SERVICE BULLETIN

APPLICABILITY: 2019-24MY Ascent
2020-24MY Outback & Legacy 2.4L

NUMBER: 09-130-25R

SUBJECT: Exhaust Manifold Flange Nut / Torque & Design Change

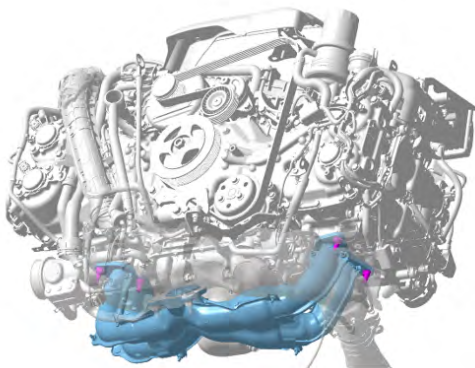
This bulletin announces the design change made to the exhaust manifold flange nuts. The material has been changed from a medium carbon steel to stainless steel. This change also necessitates a revised tightening torque specification. When replacement of the flange nuts is required, follow the part and service procedure information outlined in this bulletin.

EX-10353

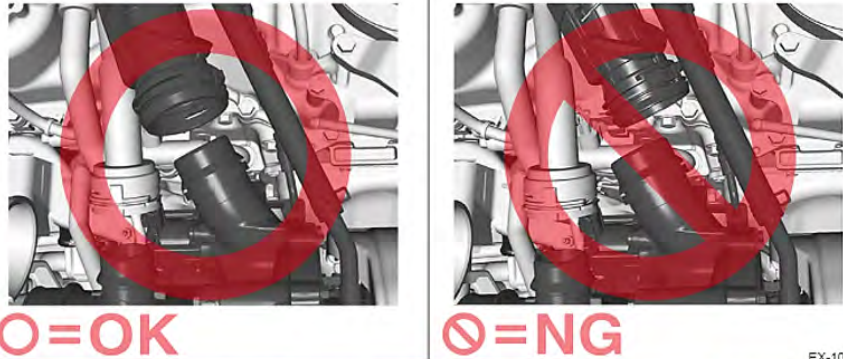
The torque procedure has been changed from a one-time torque of 65 Nm (6.6 kgf-m, 47.9 ft-lbs) to a two-step procedure with an initial torque of 55 Nm (5.6 kgf-m, 40.6 ft-lbs) then a final torque of 65 Nm (6.6 kgf-m, 47.9 ft-lbs). A section of the Service Manual is pictured below. The added service procedure (4.) has been outlined in **RED** and will be added to the applicable Service Manual in the future.

EX-10326

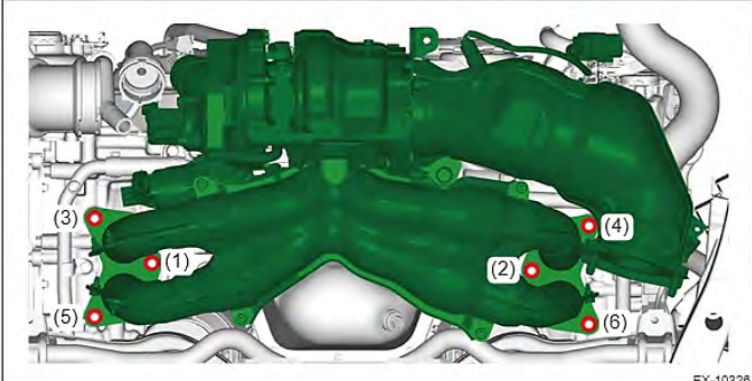
Added Step

4. Tighten the nuts in the numerical order as shown in the figure.
Tightening torque:
55 N·m (5.6 kgf-m, 40.6 ft-lb)

5. Tighten the nuts again in the numerical order as shown in the figure.
Tightening torque:
65 N·m (6.6 kgf-m, 47.9 ft-lb)
